# INNER WEST COUNCIL

## DEVELOPMENT ASSESSMENT REPORT

| <b>Application No.</b>                            | DA201600172.02   |
| <b>Proposal</b>                                   | To construct a support wall against the southern boundary wall to enable the retention of the existing southern boundary wall in its entirety and to setback the southern basement wall by 700mm |

PROPOSED CONDITIONS (GRID B)  
(Scale 1:50)

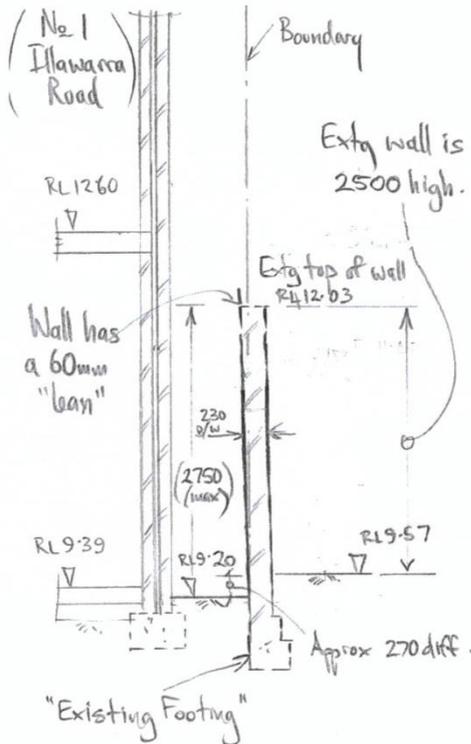
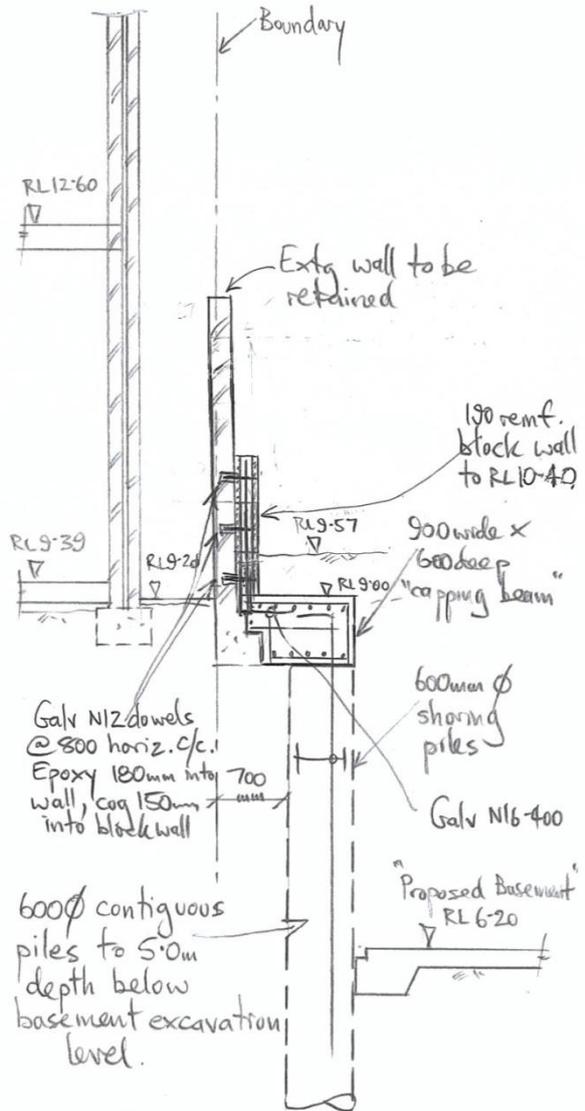
Re: 110-112 Addison Rd, Marrickville - (Amended Boundary Wall with 1 Illawarra Rd)

EXISTING CONDITIONS (GRID B)  
(Scale 1:50)

The "shoring piles" have been relocated along this boundary by some 700mm in towards the centre of the site. This should provide sufficient clearance for the piling rig to install the 9.0m deep piles along this elevation, and still allow for a continuous concrete capping beam to be poured parallel with the boundary wall footing which is to be maintained.

The sequence of works will involve removal of the current steel framed awning and progressive installation of the bored piers parallel with the wall. This boundary wall is wholly within the 110-112 Addison Rd property, and will be safe for the short time frame required to install the piles and new supporting reinforced blockwork wall. The existing neighbours services and pergola which have been attached to this wall could remain for the time being. The new 600mm shoring piles have been designed based on the recommended guidelines contained in the geotechnical engineers report, and will be safe to retain the existing masonry fence as well as the existing 2 storey house located at 1 Illawarra Rd. The new solution introduces a reinforced block retaining wall which will ultimately be used to contain the proposed garden beds along this side of the development.

SECTION @ GRID (C) (Scale 1:50)

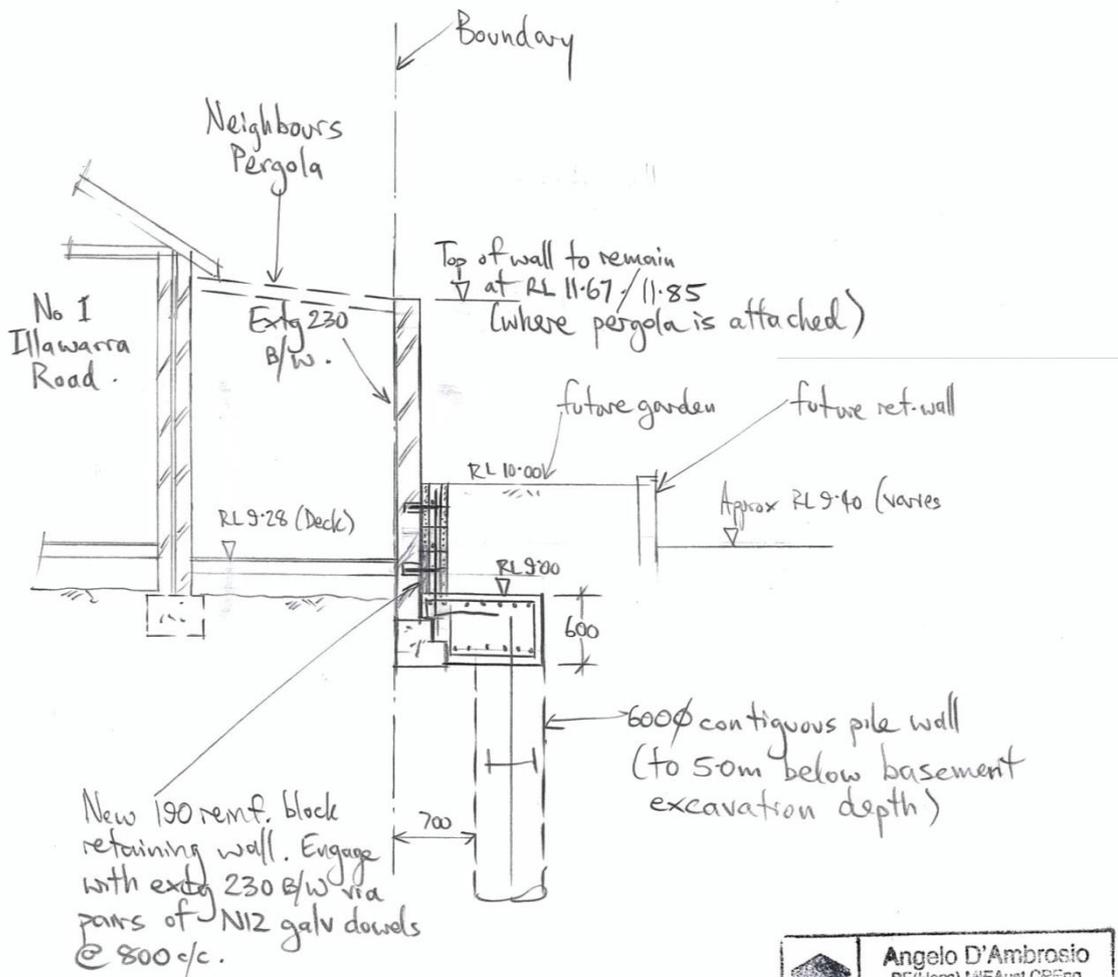
Re: 110-112 Addison Rd, Marrickville - Boundary Wall with  
1 Illawarra Rd.
